Comments on the design of Streets and Cycleway Network in the Road Works for PWP Item Nos. 7787CL (Part) and 7829CL Hung Shui Kiu/Ha Tsuen New Development Area Advance Works Phase 3 and Stage 2 Works – Site Formation and Engineering Infrastructure

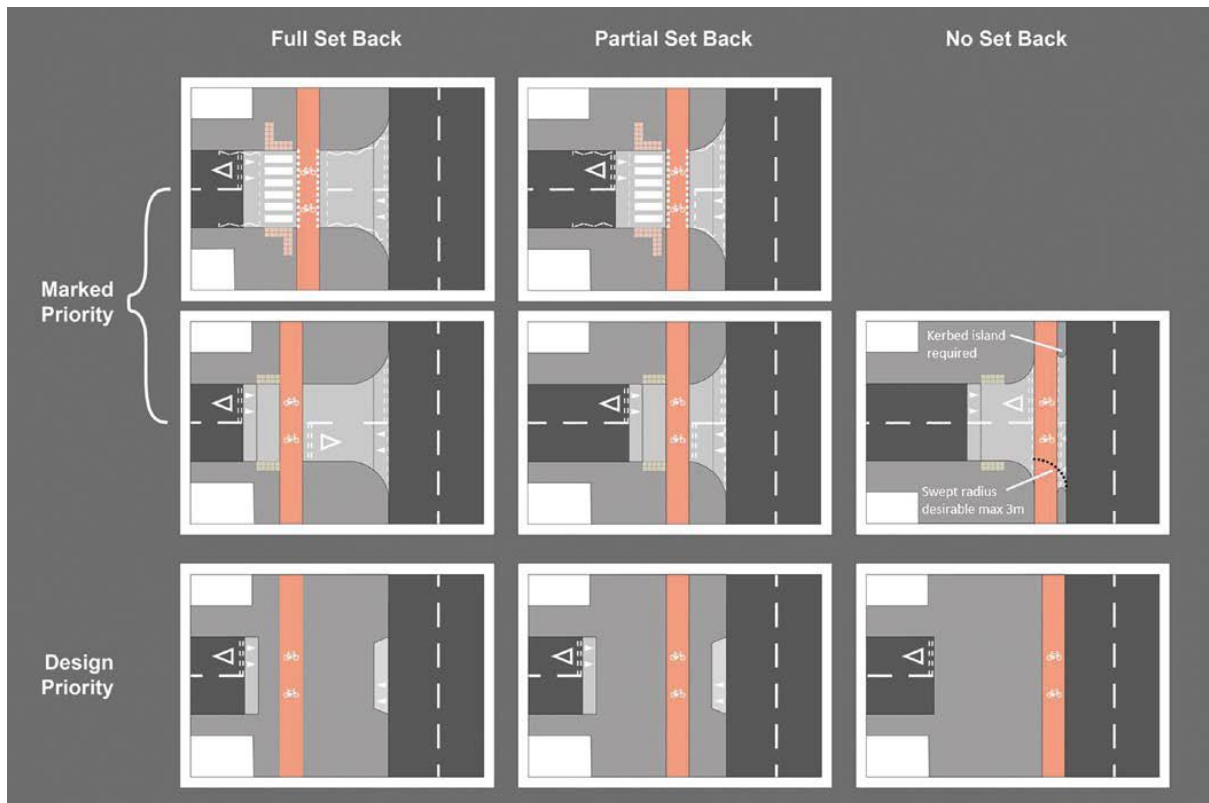
- 4.4. We are aware that cycle tracks in the NDAs are now universally designed to terminate at junctions (like the screenshots provide below), which we believe is an outdated practice and they should be redesigned to provide continuity across junctions or vehicle accesses.

- 4.5. “Giving up at junctions” - i.e. requiring cyclists to give way at every side road it

encounter, will affect the directness and coherence of the route and would result in the following two scenarios even if it is less safe:

- Cyclist non-compliance upon junction, i.e. not dismounting as suggested and required without adequate junction treatment
- Cyclist choosing the ride on the main carriageway as it is faster and more direct

4.6. A well-designed facility should not see any discontinuity in the journey as it is highly disruptive. Therefore any instruction instructing cyclists to dismount, especially across junctions is deemed inappropriate. In the UK there is now a paradigm shift moving to use more positive language & instructions instead, say “Cyclist to rejoin carriageway”, “Give way” or simply by design implementing appropriate junction/ crossing interventions.
